LATE REPRESENTATIONS

Committee PLANNING COMMITTEE

Date and Time of Meeting WEDNESDAY, 10 JANUARY 2018, 1.30 PM

LATE REPRESENTATIONS SCHEDULE
PLANNING COMMITTEE – 10th JANUARY 2018

Extract from 'Proposed Site Plan - Sheet 1'

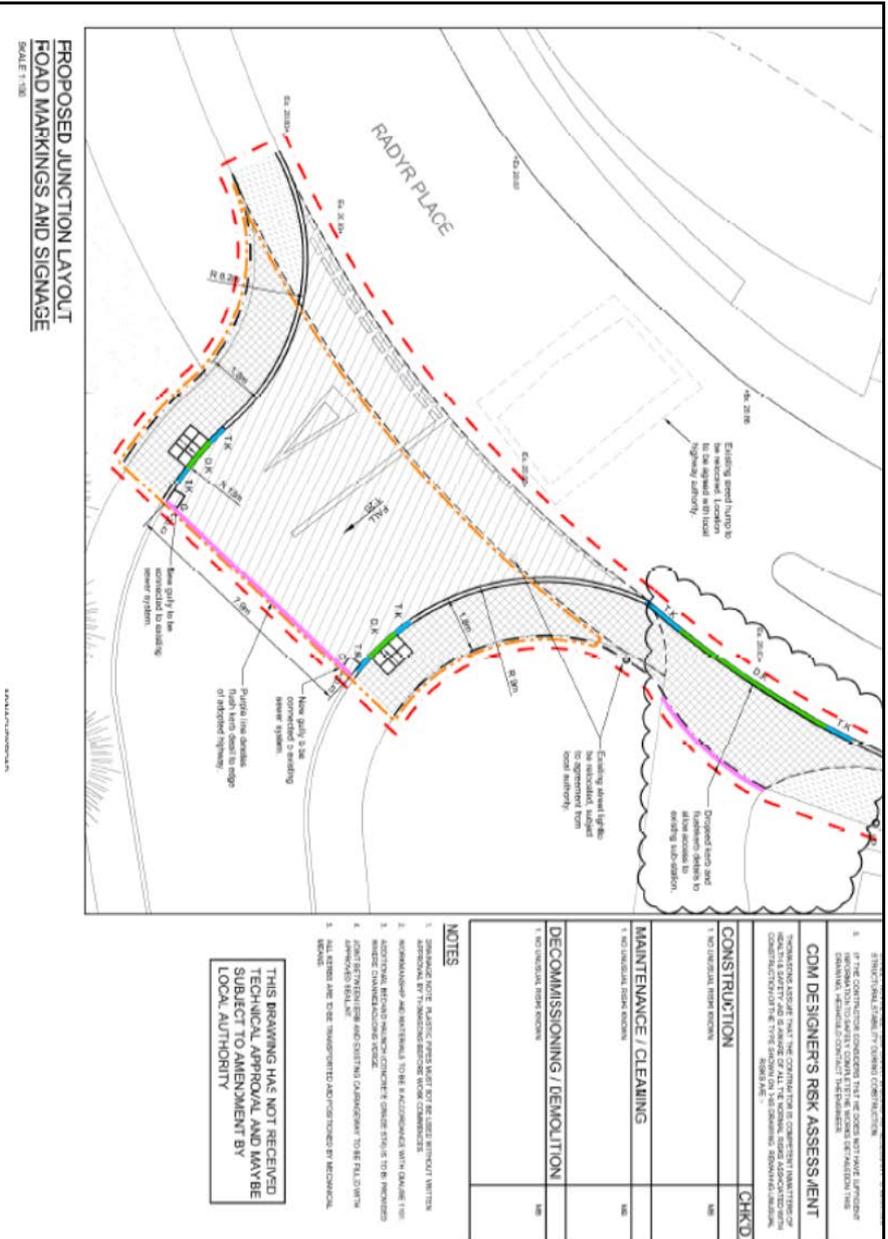
This is some way on from the **current access**, the white markings of which are in line with the bollard on the traffic island.

Here is the junction shaped as in 17/00985/MJR but with its mid-point close to the tip of the traffic island. **This is not the same spot as access through the current speed bumps and street light on the Radyr Place bend.**

<p>REMARKS:</p>	<p>A condition controlling the design of the site access/junction is proposed, as was previously the case within the 11/00863/DCI application. The location of the proposed access point would now be in the approximate location of the existing access point, albeit being widened. The proposed access would form a single shared access serving the student development and community centre proposal.</p>

The Operational Manager – Highways confirms that the access arrangement shown in the application would be acceptable (subject to detailed design and approval condition). The proposed access arrangement (17/01963 - L(01)021 Rev A) would facilitate access to the proposed student accommodation, institute and electricity substation. The provision of a single access point would be preferable in safety terms.

The visibility splay from the proposed junctions provides adequate minimum stopping distance (50m) for a HGV in wet conditions for vehicles traveling at 30 mph (in accordance with Manual for Streets 2).
